Combustible façade cladding – preliminary fire safety assessment

ACT Health Procurement and Capital Works
Centenary Hospital for Women and Children,
Garran, ACT

CA170095

Revision FSA1.1 | 3 August 2017

Figure 2. Floor Slabs Typical panel attachment detail (AR-F-XX-01).

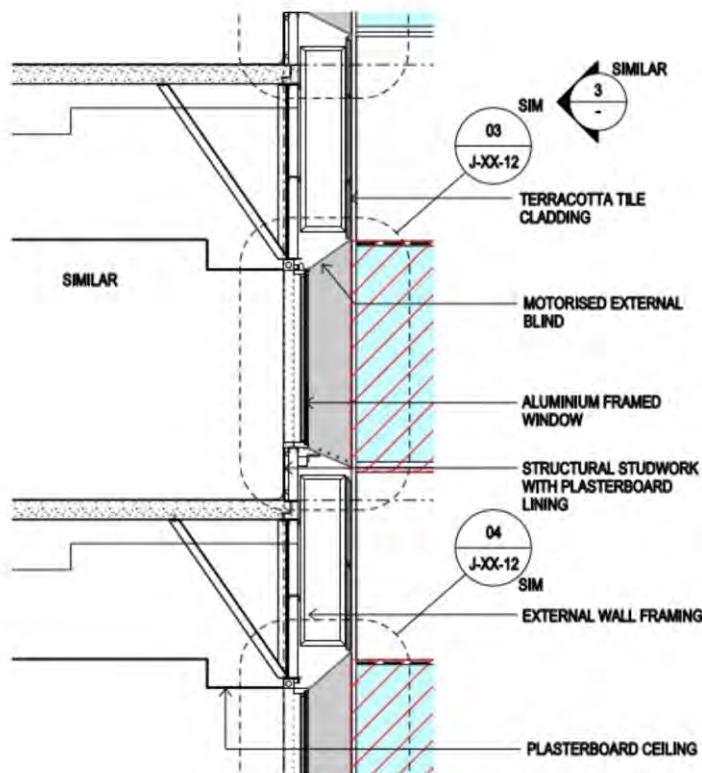
In Figure 2, the horizontal floor slabs defining each floor level are shown. Coming out from the slabs at an angle, are the steel purlins which attach to the façade support frame. The steel stubs are bolted to the floor slab. The façade support frame is composed of a square grid of galvanised steel channelling.

Figure 3. Typical ALUCOBOND Attachment Detail. Note Zinc Sheet and backing channels / purlins (EB-G-XX-2026)

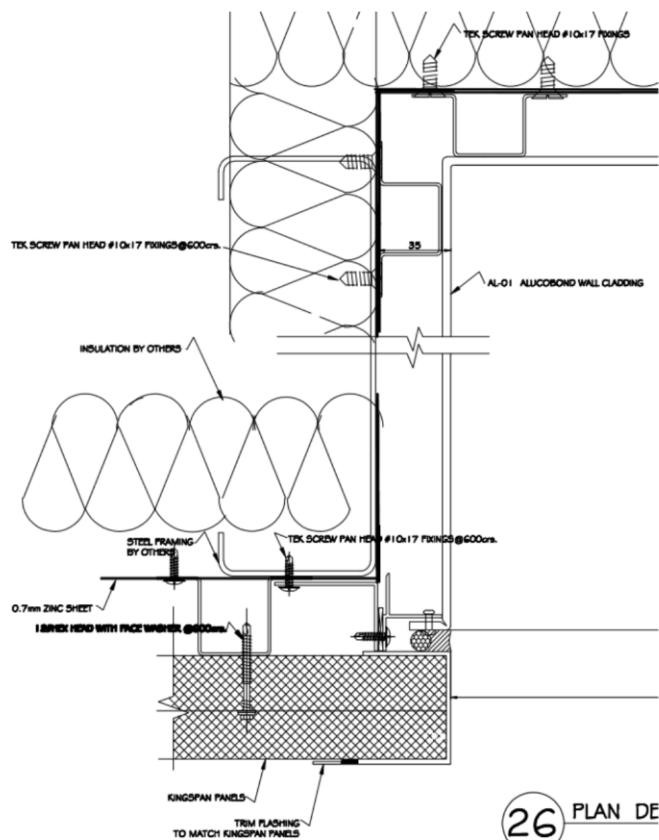
In general, the exterior panels are screwed onto a grid of galvanised steel channels which make up the façade support structure. Between the exterior panels and the façade support structure is continuous 0.7mm galvanized steel sheeting (also called 'Zinc Sheet' and occasionally in the drawings, it appears to be mentioned as a 'membrane'). Removal of the outside panels is likely to reveal a continuous membrane of zinc sheet, at least in the areas inspected. Only detailed scrutiny of all the drawings would reveal if this is indeed the standard practice or not.
